UNITED STATES
NUCLEAR REGULATORY COMMISSION
WASHINGTON, D. C. 20555

February 22, 1980

These amendments revise the Technical Specifications to support the operation of Oconee Unit No. 1 at full rated power during Cycle 6. The amendments also revise the Technical Specifications for Units Nos. 1, 2, and 3 in regard to engineered safety features.

Enclosures:
1. Amendment No. 81 to DPR-38
2. Amendment No. 81 to DPR-47
3. Amendment No. 78 to DPR-55
4. Safety Evaluation
5. Notice of Issuance

CORE PROTECTION
SAFETY LIMITS
UNIT 1
OCONEE NUCLEAR STATION
Figure 2.1-2A

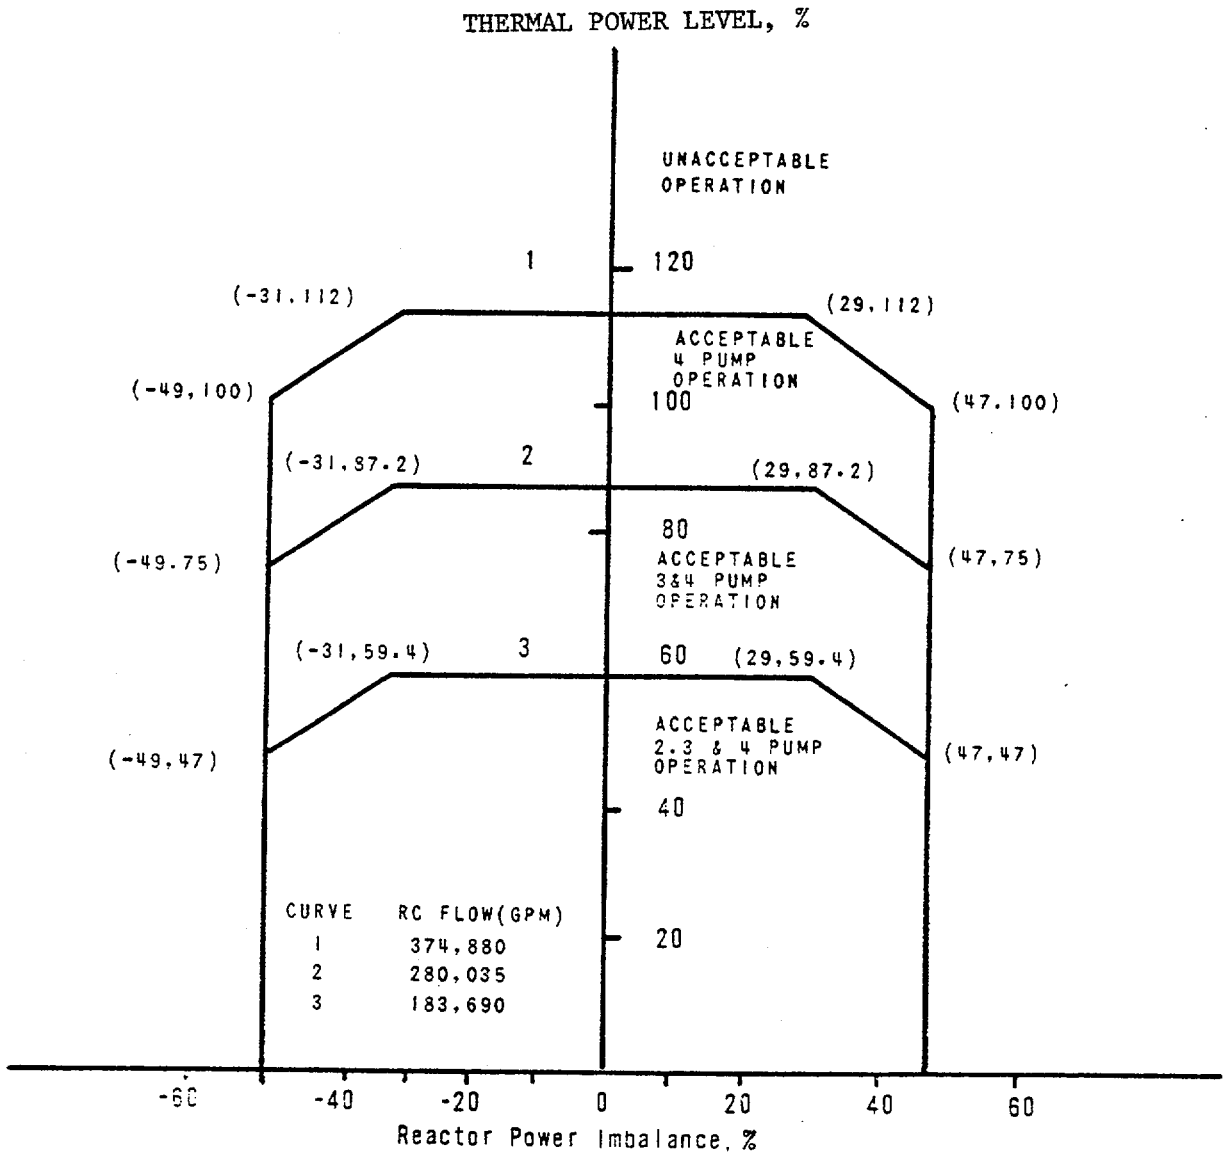
The curves of Figure 2.1-2A are based on the more restrictive of two thermal limits and include the effects of potential fuel densification and rod bowing:

1. The 1.30 DNBR limit produced by the combination of the radial peak, axial peak and position of the axial peak that yields no less than a 1.30 DNBR.

2. The combination of radial and axial peak that causes central fuel melting at the hot spot. The limit is 20.05 kw/ft for Unit 1. (3)

The specified flow rates for Curves 1, 2, and 3 of Figure 2.1-2A correspond to the expected minimum flow rates with four pumps, three pumps, and one pump in each loop, respectively.

PROTECTIVE SYSTEM
MAXIMUM ALLOWABLE SETPOINTS
UNIT 1
OCONEE NUCLEAR STATION
Figure 2.3-2A

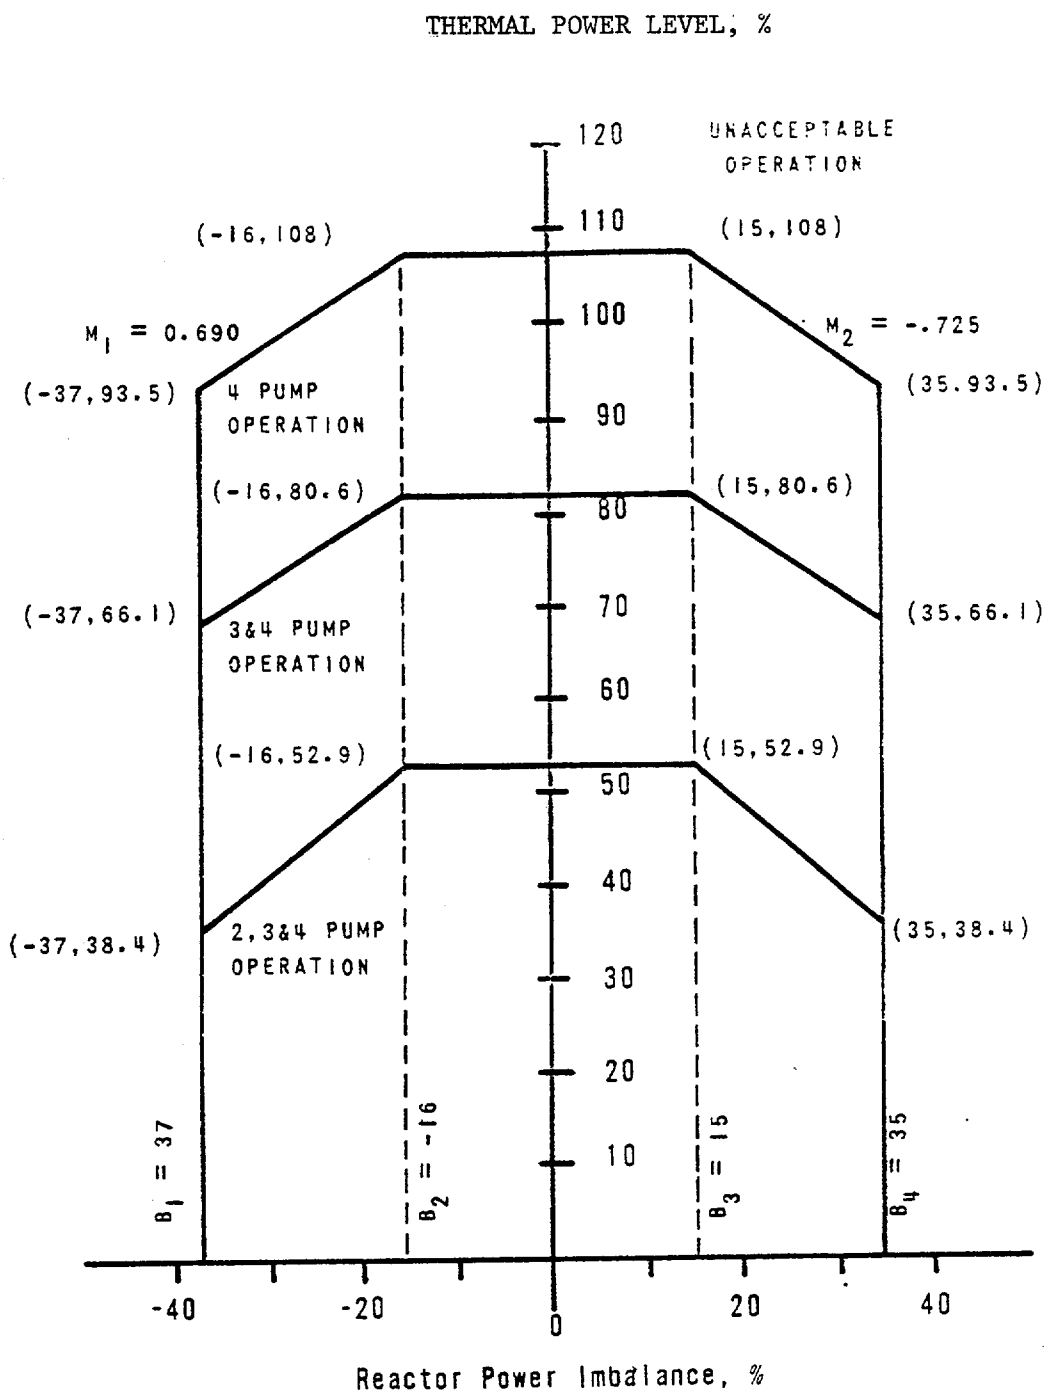
The power-imbalance boundaries are established in order to prevent reactor thermal limits from being exceeded. These thermal limits are either power peaking kw/ft limits or DNBR limits. The reactor power imbalance (power in the top half of core minus power in the bottom half of core) reduces the power level trip produced by the power-to-flow ratio such that the boundaries of Figure 2.3-2A - Unit 1 are produced. The power-to-flow ratio reduces the power
2.3-2B - Unit 2
2.3-2C - Unit 3

level trip and associated reactor power/reactor power-imbalance boundaries by 1.08% - Unit 1 for 1% flow reduction.
1.055% - Unit 2
1.08% - Unit 3
